report # 2639 (3 pages)

RE: Arborist report - 1851 Appletree Lane, Mountain View

Plans reviewed:

Proposed site plan, Cornelia Haber Residential Design, dated October 15, 2023

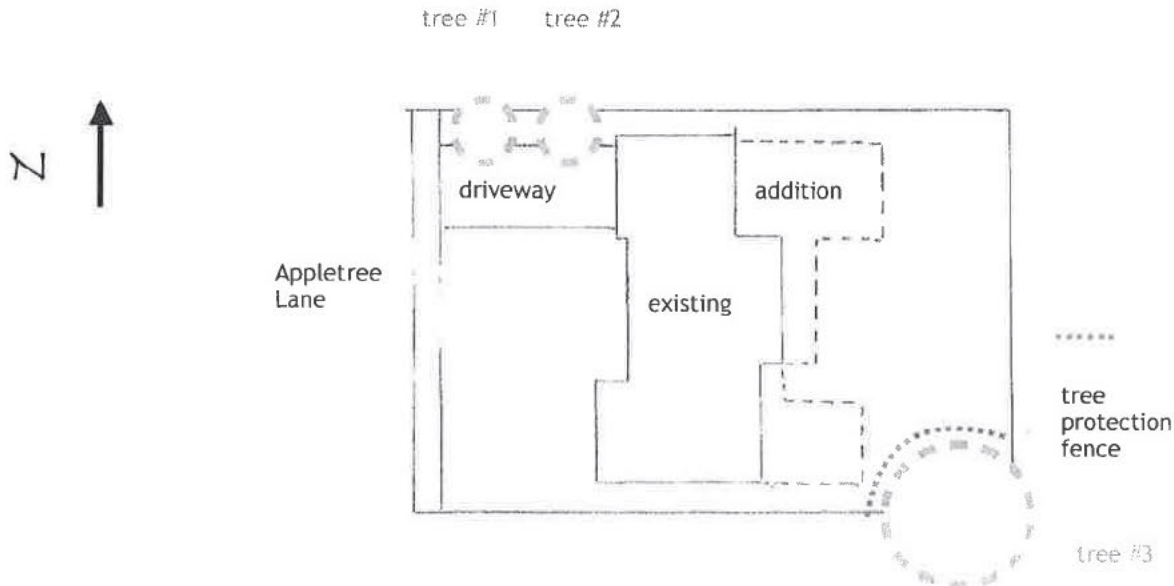
Brief description of work - Addition to the single family residence. Three trees qualifying as Heritage trees (per Mountain View tree ordinance) are marked on the following site drawing. Two Liquidambar trees are being requested for removal. One Cedrus on the neighboring property to the south is to be protected.

The footprint of the home addition approaches the root zone of Tree #3 in the back yard. An appropriate tree protection measure is to fence off an area around the tree to prohibit the movement of heavy equipment over the critical root zone or the storage of construction materials on top of the critical root zone. In this case, I believe a reasonable definition of the critical root zone is the drip line of the tree (the edge of the leafy canopy). The distance from the trunk in this case is a radius of approximately 15'. The fence shall be 5' in height, made of chain link. It must be installed prior to any construction activity. It is reasonably unlikely that very many roots outside this defined area will be larger than 2" in diameter. However, in the process of constructing the foundation for the addition, roots of this size may be encountered. It may be difficult to determine if the roots are from the Cedar or other shrubby vegetation that is nearby. In any case, roots that need to be cut, should be cut cleanly with well sharpened tools.

tree condition	Trunk circumference at 54" from grade	method of critical root zone protection
tree #3 (Cedrus deodara)	fair	122.5"	5' high chain link fence at drip line

Trees #1 and #2 (both Liquidambar)

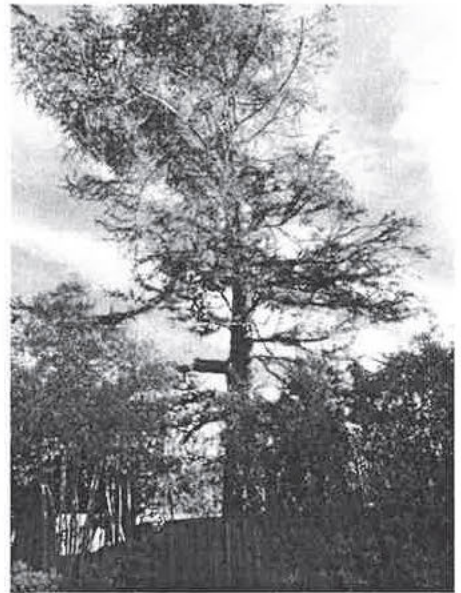
tree condition	Trunk circumference at 54" from grade	reason for removal
tree #1 (Liquidambar styraciflua)	good	52"	Tree roots are damaging driveway and sidewalk hardscape. This situation is expected to worsen with time. Tree is in a location which is in conflict with driveway improvement.
tree #2 (Liquidambar styraciflua)	good	50"	Tree roots are damaging driveway and sidewalk hardscape. This situation is expected to worsen with time. Tree is in a location which is in conflict with driveway improvement.

Tree replacement is required as a condition for removal of two Heritage Liquidambar trees. There is not ample enough space on this residential lot for the replacements to be placed there. I understand there is an option for the homeowner to pay to have replacement trees planted elsewhere in Mountain View in order to maintain the city's overall tree canopy. I don't know what that cost is, but I believe that to be the best option for you and for the successful tree canopy goals of Mountain View.
